# United States Patent and Trademark Office

APPLICATION NO.	FILING DATE	FIRST NAMED INVENTOR	ATTORNEY DOCKET NO.	CONFIRMATION NO	
10/627,346 07/25/2003		Donald G. Gordy	DUR-104	2326	
27014 75	90 05/18/2005		EXAMINER		
JOHN R. BEN	NEFIEL	FERGUSON, MICHAEL P			
280 DAINES S' #100 B	T.		ART UNIT	PAPER NUMBER	
BIRMINGHAM, MI 48009			3679		
			DATE MAILED: 05/18/2005

#### **DETAILED ACTION**

As to claim 1, Liaw discloses an arrangement for connecting one end of a rod **A** (pins **A**, Figure 2 reprinted below with annotations) to a headed pin **5** to enable engagement of the pin with the rod, comprising:

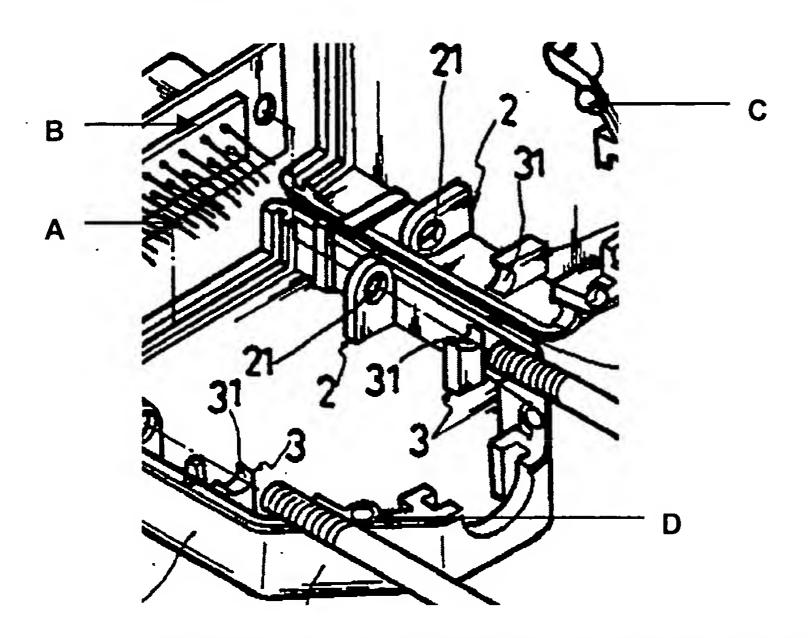
a housing 1 defining a pin receiving cavity formed therein with retention features 2,3 around the cavity engaging the headed pin so as to be retained therein;

a soft elastomeric isolator **B** (isolator **B** non-conductively isolates pins **A**) interposed between the housing and the one end of the rod;

the housing comprised of two pieces fit together and configured to enclose the isolator and also the one end of the rod, the two pieces joined together to form the housing (Figure 2).

As to claim 2, Liaw discloses an arrangement wherein the housing pieces 1 are joined together by snap fit prongs C on one housing piece received in receptacles D on the other piece (Figure 2).

As to claim 3, Liaw discloses an arrangement wherein the housing pieces 1 are molded as one part, the housing pieces connected together with an integral hinge 12 allowing the housing pieces to be swing together into abutment with each other and fit over the isolator **B** (Figure 2).

As to claim 4, Liaw discloses an arrangement wherein the housing pieces 1 each have a recess defined therein the recesses together forming a cavity when the housing pieces are assembled abutting each other enclosing the isolator **B** (Figure 2).

As to claim 9, Liaw discloses an arrangement wherein the housing piece isolator receiving cavity has an interference fit with the isolator **B** when the housing pieces **1** are assembled (Figure 2).
